Felix Buechi *et al.*  
Appl. No.: 10/608,088

**Amendments to the Drawings:**

Appl.No. 10/608,088  
 Reply to Office action of February 2, 2006  
 Annotated Sheet Showing Changes

Fig. 1 (Prior Art) added

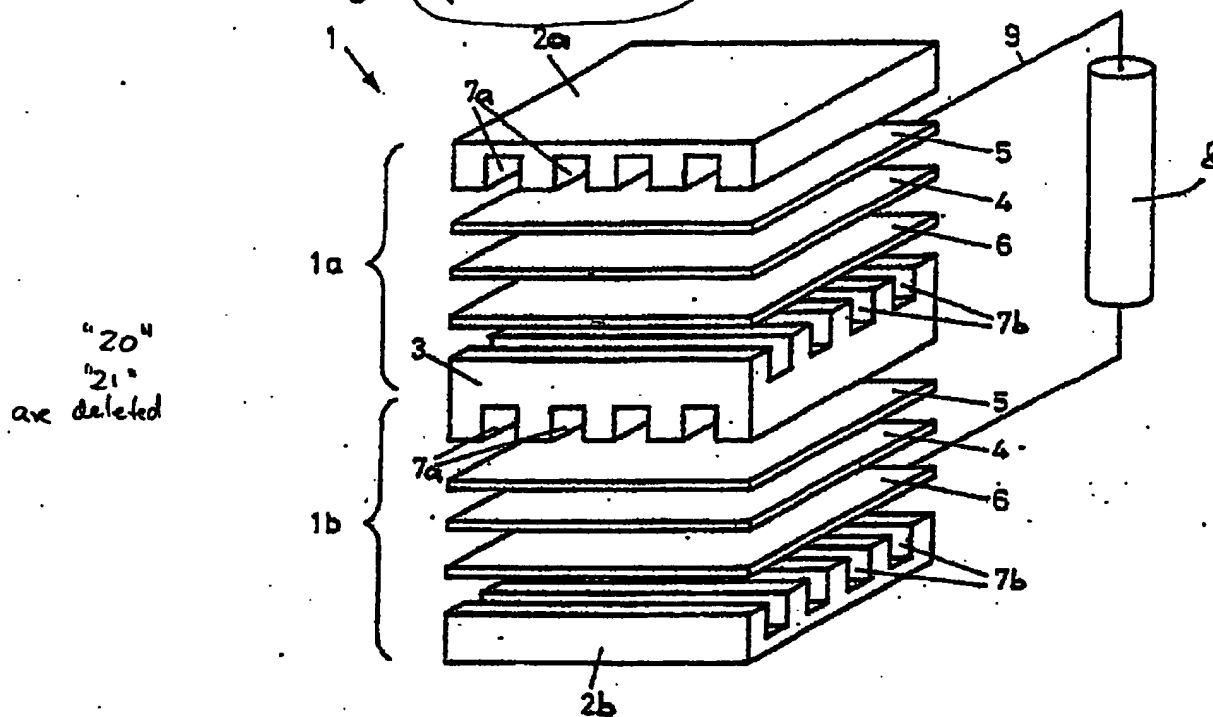
Figure 1 has been labeled as “Prior Art.” Further, in Figure 1, reference numerals 20 and 21 have been deleted.

The Examiner objects to the drawings under 37 C.F.R. §1.84(p)(5) for showing reference numerals not mentioned in the description, and under 37 C.F.R. §1.84(p)(4) for improperly using reference numerals for different items. Further, the Examiner requests labeling Figures 1 and 2 as Prior Art.

In Figure 1, reference numerals 20 and 21 have been deleted.

Fig. 2 (Prior Art) added

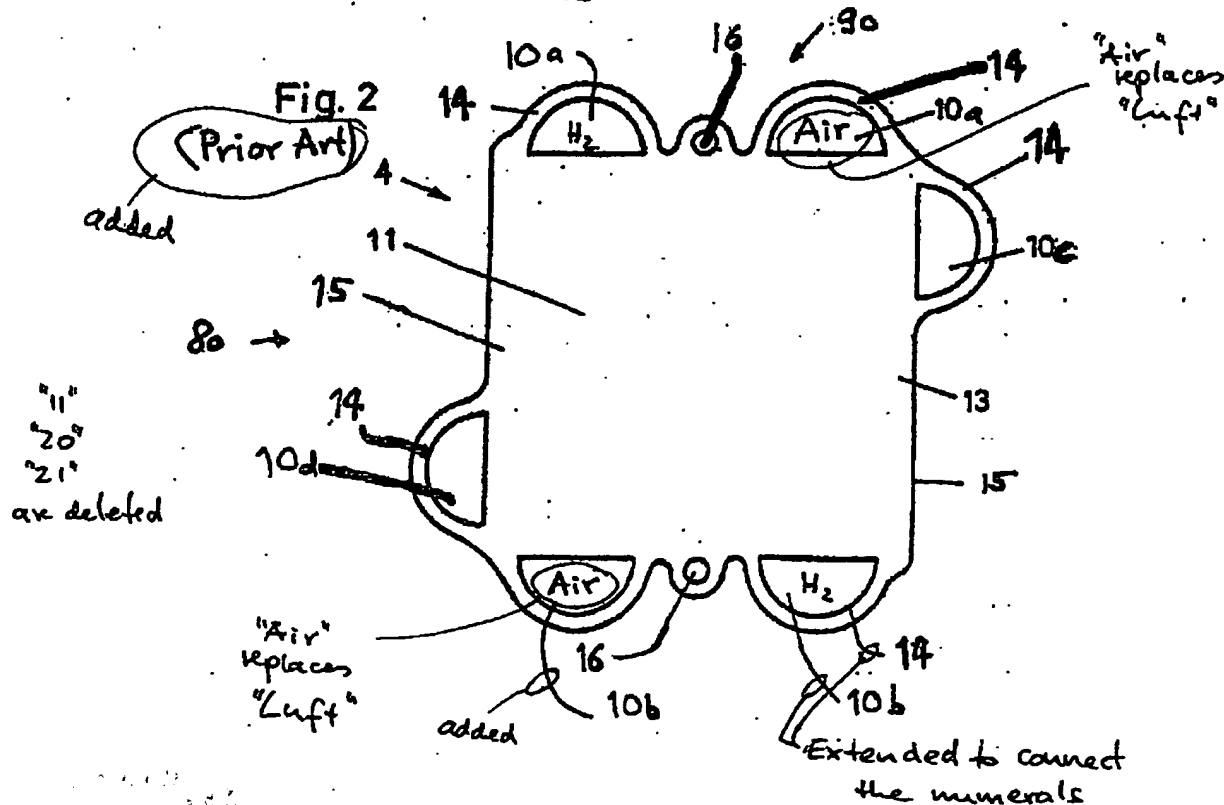
Figure 2 has been labeled as “Prior Art.” Further, reference numerals 11, 20 and 21 have been deleted. Lead lines and corresponding reference numerals have been clarified. German word “Luft” has been replaced by “Air.”

In Figure 2, reference numerals 11, 20 and 21 have been deleted. Lead lines and corresponding reference numerals have been clarified. German word "Luft" has been replaced by "Air."

Fig 3

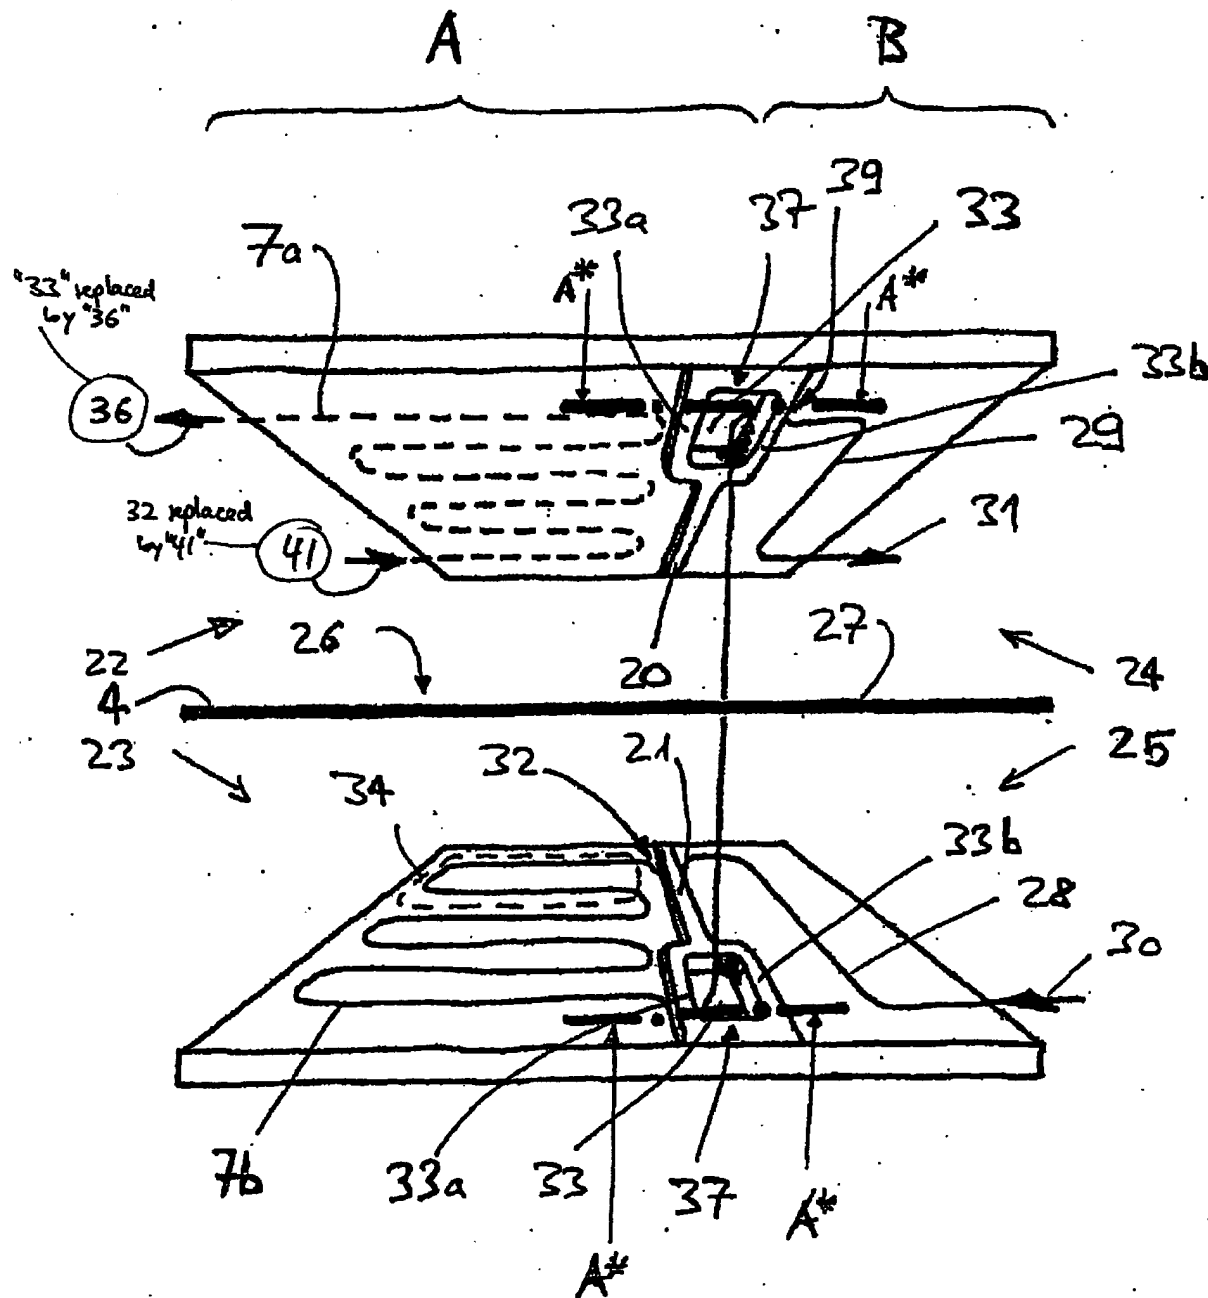
Figure 3 has been amended to label arrows as 36, 41 to avoid double use of numerals 32, 33.

In Figure 3, arrows at the input and output of channel 7a have been labeled as 36, 41 to avoid double use of numerals 32, 33.
